Castel Maggiore, July 2nd 2007
To all our customers

SUBJECT: UPGRADED SEQUENTIAL SYSTEM: PRESSURE REGULATOR RP/G05S

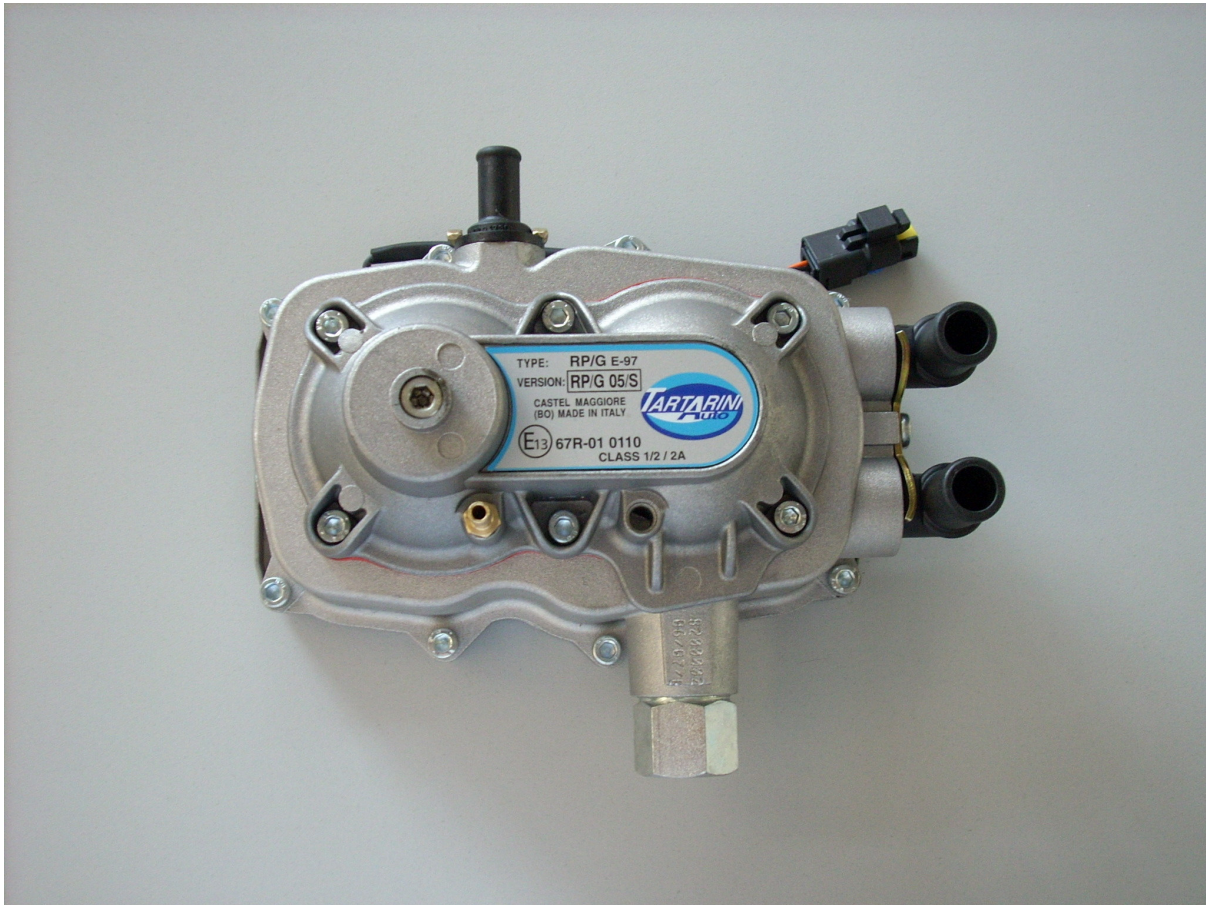
The new gas-outlet is straight for improving the flow of the LPG out of the regulator. The following chart explains exactly the improvements:

Portata massima	+5%
Capacità di scambio termico	+10%
Peso	-7%

All other characteristics, such as installation and connection to the other pneumatic and electrical components of our system, **remain totally unchanged**.

The upgrade has already become part of our standard production starting from 26th June 2007 and it will involve all the kits with pressure regulator RP/G 05 S.
